RE: Summerfield Pointe P.U.D. Amendment & Site Plan Applications

Please find enclosed two (4) sets of revised, signed and sealed set of plans for the proposed improvements to take place at the Summerfield Pointe PUD. These revisions have been done based on review letters as received by the Township and dated 03/16/22 & 03/18/22.

TETRA TECH Review Comments:

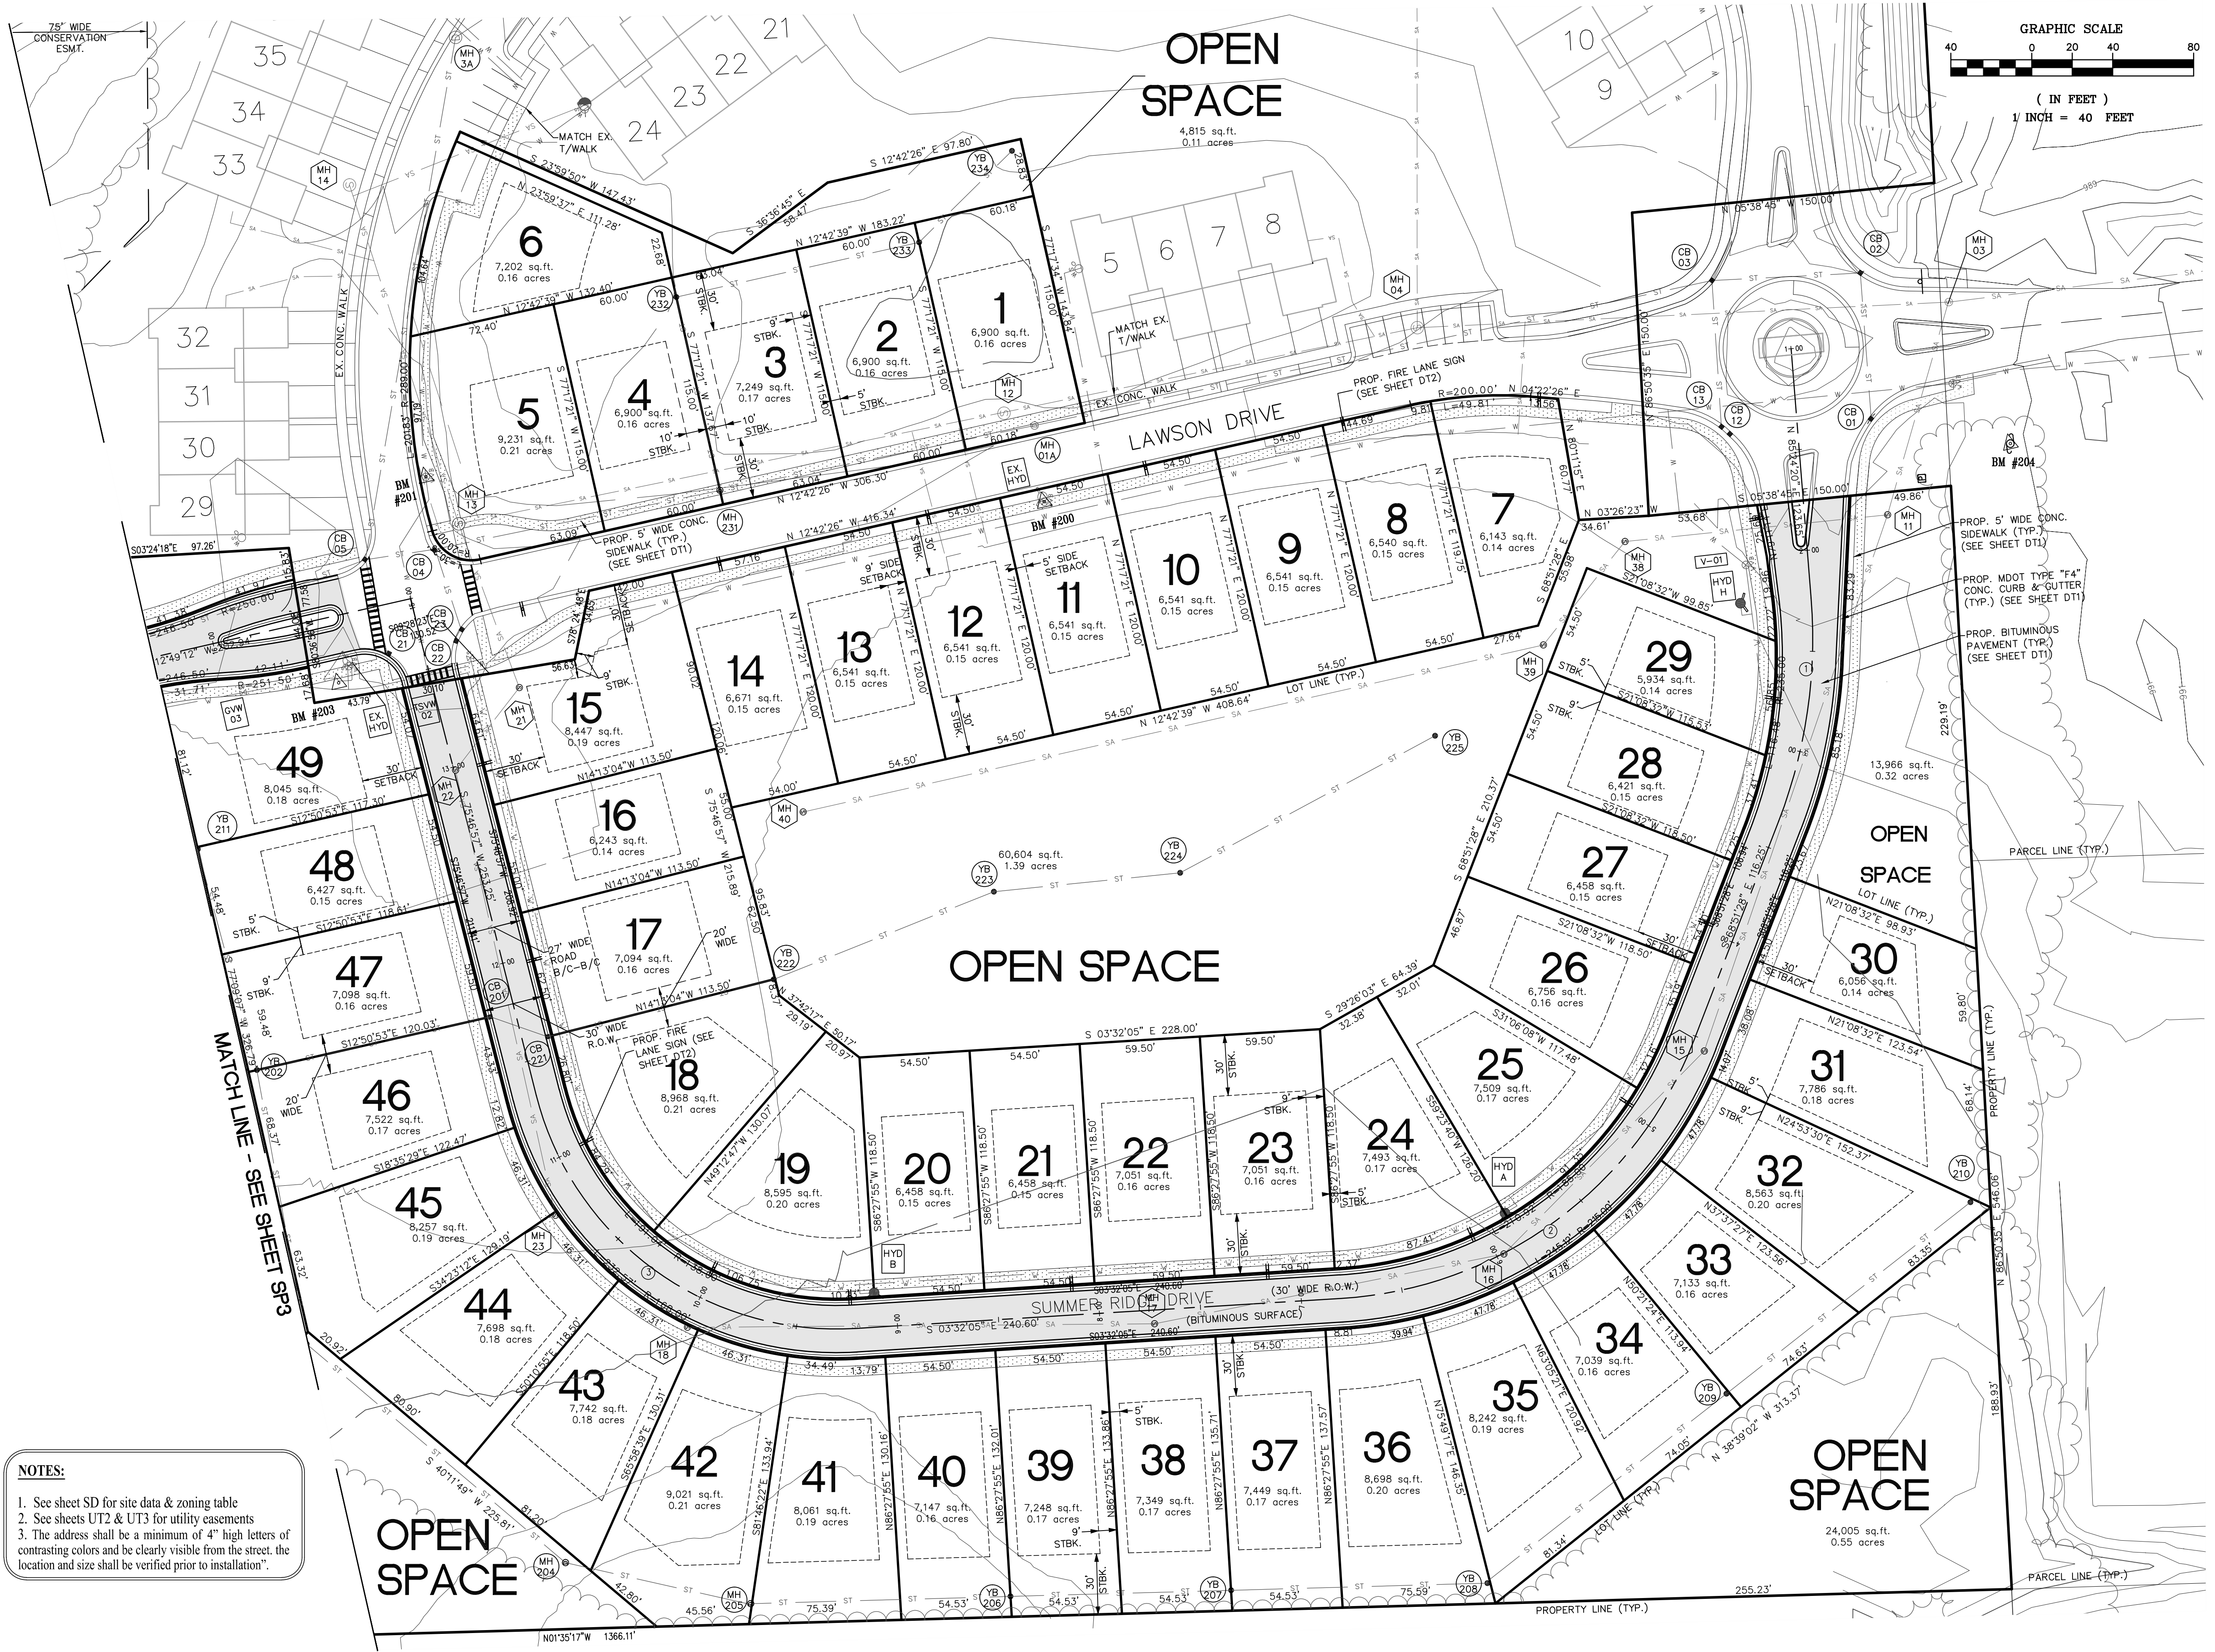
3. A note has been added on sheets SP1 & SP2 of plans stating "The address shall be a minimum of 4" high letters of contrasting colors and be clearly visible from the street. The location and size shall be verified prior to installation".

- See sheet SD for site data & zoning table
- See sheets UT2 & UT3 for utility easements
- The address shall be a minimum of 4" high letters of contrasting colors and be clearly visible from the street, the location and size shall be verified prior to installation".

TYPICAL CROSS SECTION FOR LAWSON DRIVE & SUMMER RIDGE DRIVE PRIVATE ROADS

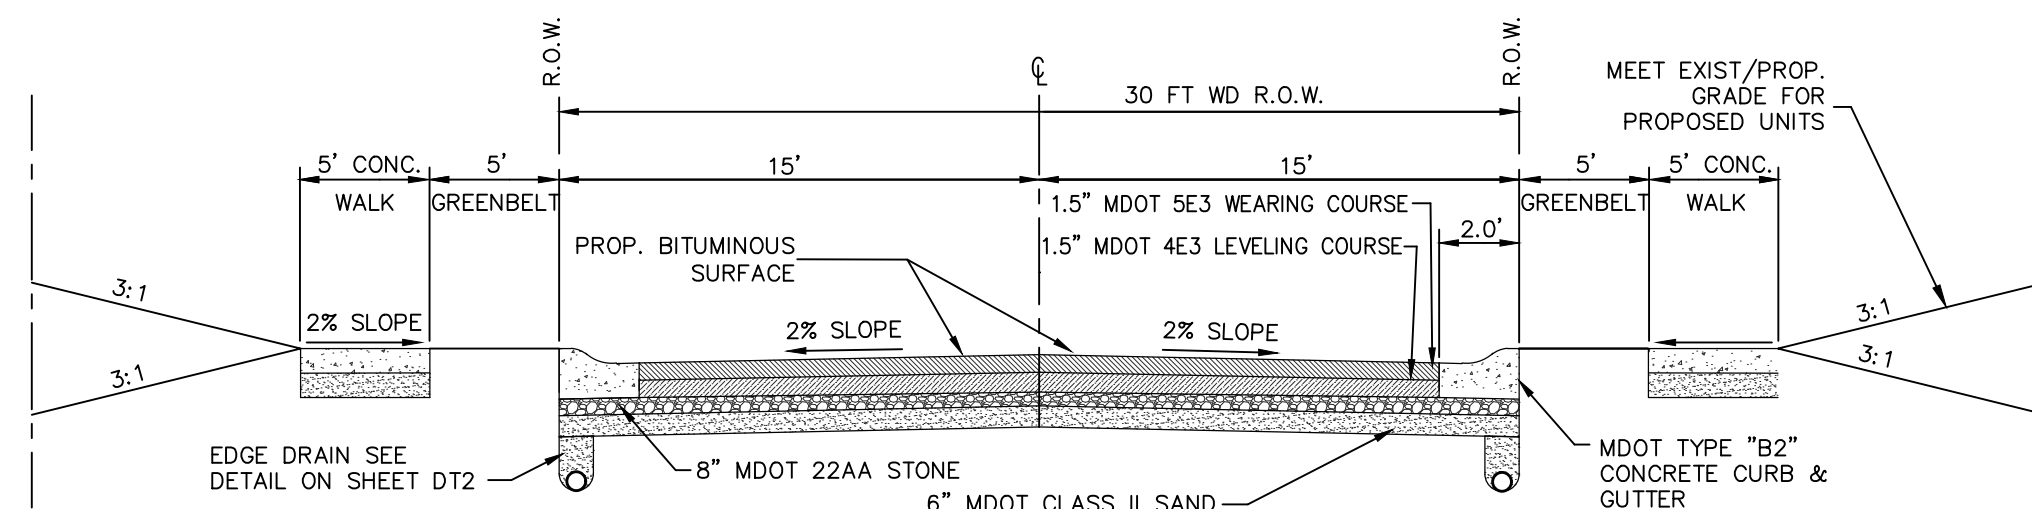
The proposed cross section for Lawson Drive & Summer Ridge Drive has been revised on sheet DT1 per Engineer & Planner review comments.

SIDEWALK CROSS SECTION

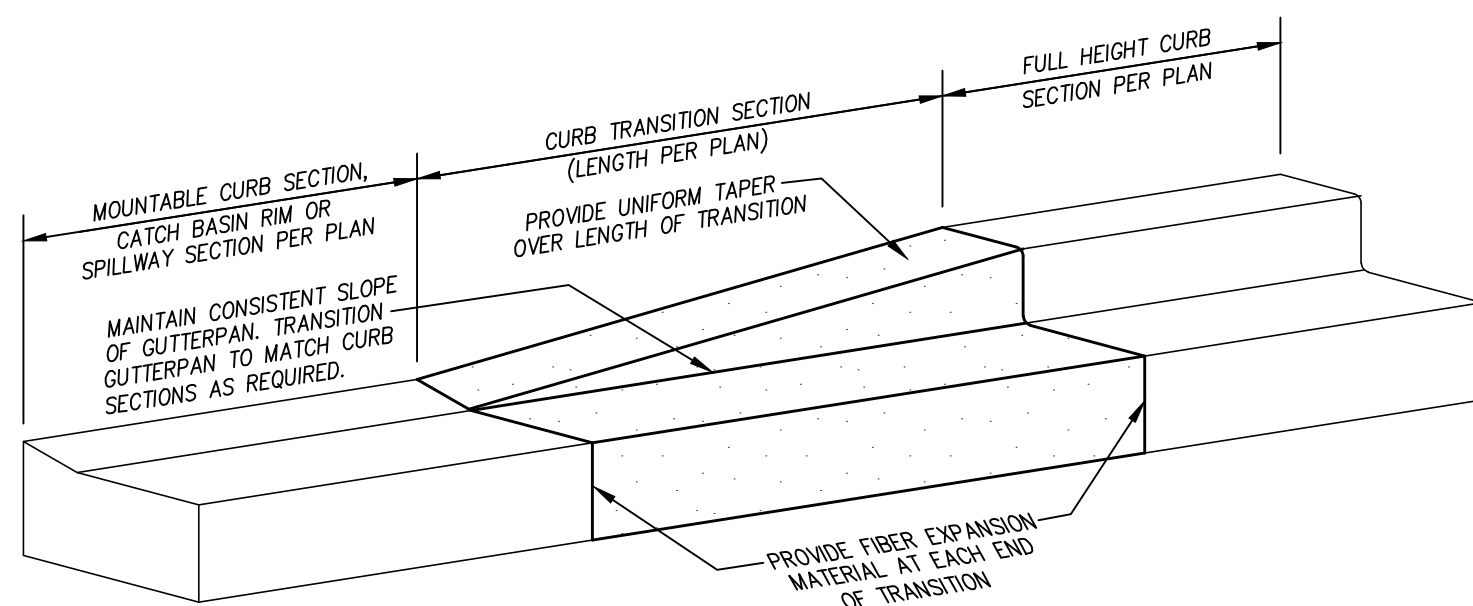
2. Sections 8.4a & 8.4b of the PUD agreement have been revised per review comments. The document has been included on the revised package for the Township.
3. The sidewalk x-sec has been revised to 6" of CLII sand base. A note has been included stating the sidewalk width shall be 6" of class "A" concrete at all driveway crossings. Likewise, the aggregate x-sec for the proposed roads has been revised to 8" of 22A. Summer Ridge drive has been included on the proposed pavement detail title for construction.
4. A 25' wd. wetland setback has been revised and shown on plan sheets accordingly.
